Model: Adonis-C2 DF70		Date: 22-Jun-01	No.: MB351001
Modified Article: Top Cover and Rear Cover		Prepared by: E. Fukuyama	
From: Technical Services Dept., GTS Division			
Reason for Modification:	☒ Parts catalog correction ☐ To facilitate assembly ☐ Part standardization	☐ Vendor change ☐ To improve reliability ☐ Other	☐ To meet standards ()

Model: Adonis-C2 ARDF (DF70)		Date: 16-Sep-04	No.: MB351008
Modified Article: Platen Sheet		Prepared by: K. Takagi	
From: 1st Tech. Support Sec. Service Support Dept.			
Reason for Modification:	☐ Parts catalog correction ☐ To facilitate assembly ☒ Part standardization	☐ Vendor change ☐ To improve reliability ☐ Other	☐ To meet standards ()

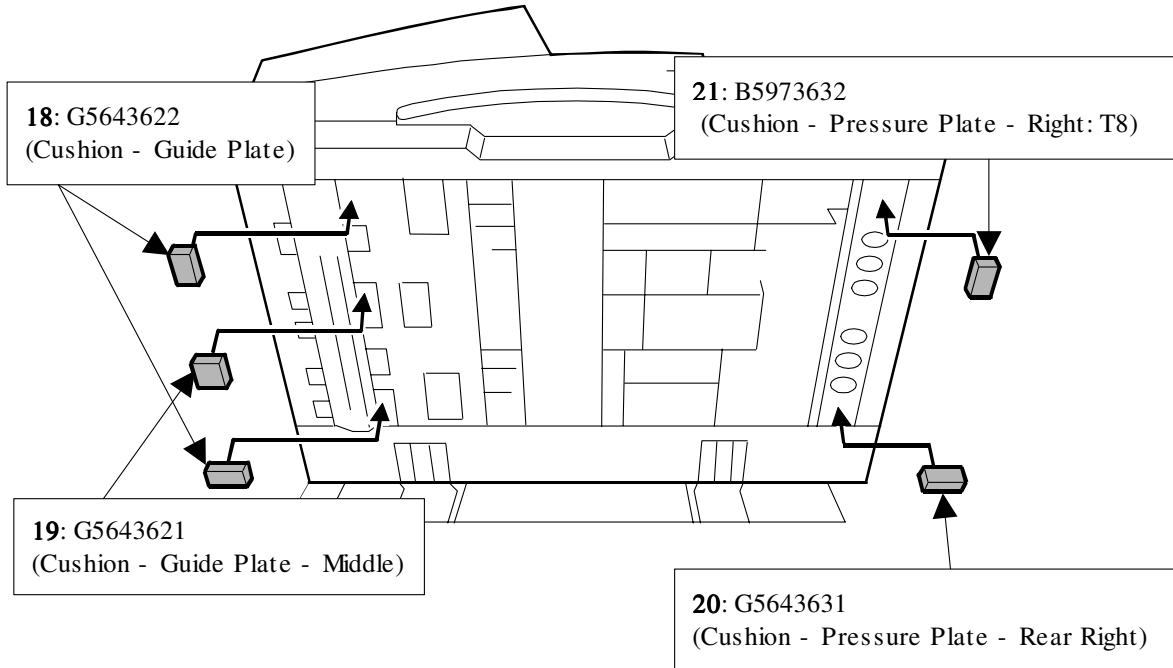
Old part number	New part number	Description	Q'ty	Int	Page	Index	Note
B3514311		Platen Sheet					
	B5974311	Pressure Plate Assy	1	X/O	21	10	
B3514333	-	Cushion - Pressure Plate	2-0		21	15	
B3514322	B3514322	Tape - Platen Sheet	4-1		21	9	
	B5974326	Cushion Tape - Left	2		21	16	
	B5974333	Cushion Tape - Middle	2		21	17	
	G5643622	Cushion - Guide Plate	2		21	18	
	G5643621	Cushion - Guide Plate - Middle	1		21	19	
	G5643631	Cushion - Pressure Plate - Rear Right	1		21	20	
	B5973632	Cushion - Pressure Plate - Right: T8	1		21	21

Reason: Parts standardization with the Model - JC1 ARDF (DF77).

Important: See the next page for important notes on installing the new parts.

Installing the Velcro Patches (“Cushion” and “Cushion Tape”)

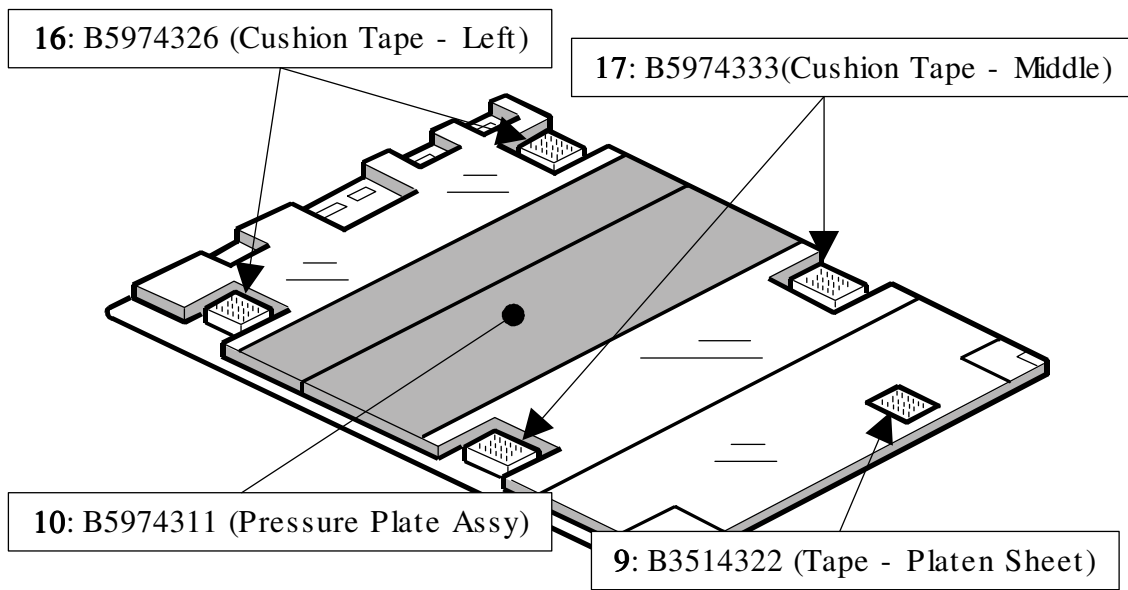
1. Remove the Platen Sheet.
2. Remove the 5 old Velcro patches from the underside of the ADF.
3. Attach the new Velcro patches to the underside of the ADF (#18-21 below).

4. Attach the new Velcro patches to the underside of the Pressure Plate (#9, 10, 16, 17 below):
